Access Compliance Report

Public Rights-of-Way

(Curb Ramps)

Intersection ID: N/A	Main Street: E_4TH_ST	Cross Street: JOHN_BELK_RA	Location: S
ADA ID: D7397846918B	Ramp Type: BlendTrans1	Initial Pass/Fail: Fail	Overall Compliance: No
Severity Score: 8.75			
Codes/Mitigation Info/Possible Solution		Field Measurements/Component Compliance

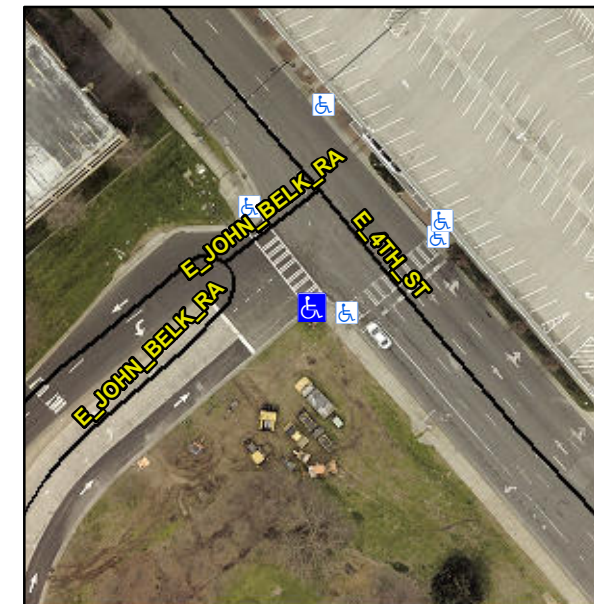
Not Found, R304.5.1

Compliance	Description	Data	Compliance	Description	Data
N/A	Ramp Length (in)	50.0	Yes	BlendTrans Slope (%)	2.6
No	Ramp Width (in)	46.0	Yes	BlendTrans XSlope (%)	1.9
N/A	Flare Type LT	N/A	N/A	Flare Type RT	N/A
N/A	Flare Slope LT (%)	N/A	N/A	Flare Slope RT (%)	N/A
N/A	Flare Traversable LT?	No	N/A	Flare Traversable RT?	No
N/A	Landing Length (in)	N/A	N/A	DWS Provided?	N/A
N/A	Landing Width (in)	N/A	N/A	DWS Contrast?	N/A
N/A	Landing Slope (%)	N/A	N/A	DWS Length (in)	N/A
N/A	Landing X Slope (%)	N/A	N/A	DWS Full Width?	N/A
N/A	Landing Curb? (Y/N)	N/A	N/A	DWS Offset (in)	N/A
N/A	Shared Landing?	N/A			
N/A	Gutter Ponding?	N/A	N/A	Gutter Slope (%)	N/A
N/A	Gutter Lip Ht (in)	N/A	N/A	Gutter X Slope (%)	N/A
N/A	Painted X Walk1?	Yes	N/A	Painted X Walk2?	N/A
	X Walk 1 Direction	To NW		X Walk 2 Direction	N/A
	X Walk 1 Width (in)	112.0		X Walk 2 Width (in)	N/A
	X Walk 1 Slope (%)	6.2		X Walk 2 Slope (%)	N/A
	X Walk 1 X Slope (%)	1.7		X Walk 2 X Slope (%)	N/A

N/A	Ramp inside XWalk1?	Yes	N/A	Ramp inside XWalk2?	N/A
	Road Slope (%)	1.7		Clear Space?	N/A
	Road X Slope (%)	6.2	N/A	Clear Space to XWalk (in)	N/A
N/A	Any Obstructions?	N/A	N/A	Storm Grate/Utility Hazard?	N/A
	Obstruction Type			Storm Grate/Utility Type	
		N/A			N/A
			Yes	Surface Condition? (G/P)	Good
			No	Curb Slope (%)	9.3

Remove & Replace Curb Ramp With Two New Directional Ramps or Equivalent.
